Technical Service Bulletin

42 Rear axle shaft leaks at differential - S4 and S5 with Quattro Sports rear differential (PR – PDU, PDR, or GH2)

42 12 11 2026049/4 July 5, 2012. Supersedes Technical Service Bulletin Group 42 number 11 – 09 dated October 25, 2011 for reasons listed below.

Figure 1. Structure of drive shaft on differential side.
(1= protective cap) (3 = inner constant velocity joint)

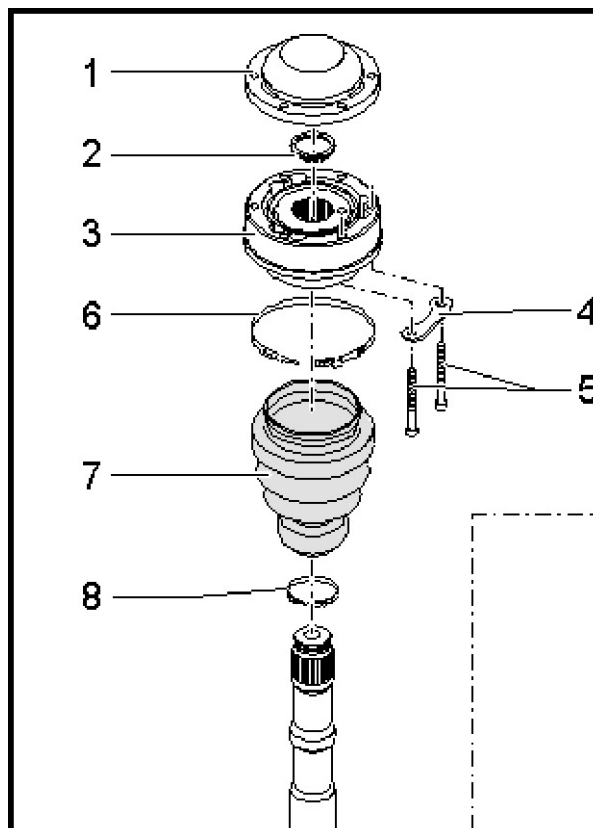
Insufficient sealant on the protective cap on the inboard constant velocity joint at the rear differential on vehicles with a sports differential.
The oil is from the constant velocity joint grease. This is a normal characteristic and does not affect the function of the driveshaft.

Optimized use of sealer in production from 05/19/2011.

Figure 2.Protective cap with sealer.

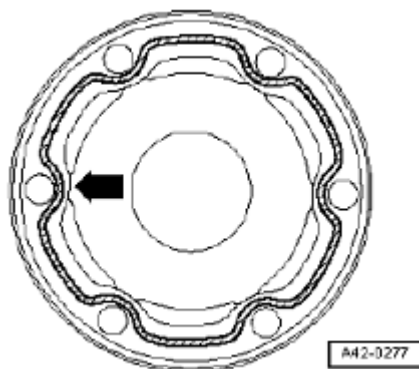
3. Per instructions in *ELSA Web >>> Chassis >>> Suspension, Wheel, Steering >>> Rear Suspension >>> Disassembly and Assembly >>> Inner CV Joint*, use great care removing the protective cap.
If the cap is undamaged after removal, it can be reused.
If the protective cap is damaged during removal, a new cap must be installed.

4. Be sure the sealing surfaces are clean and dry.
Apply the sealer (Part Number **D 454300A2**) with a diameter of **4 - 5 mm** on the protective cap.
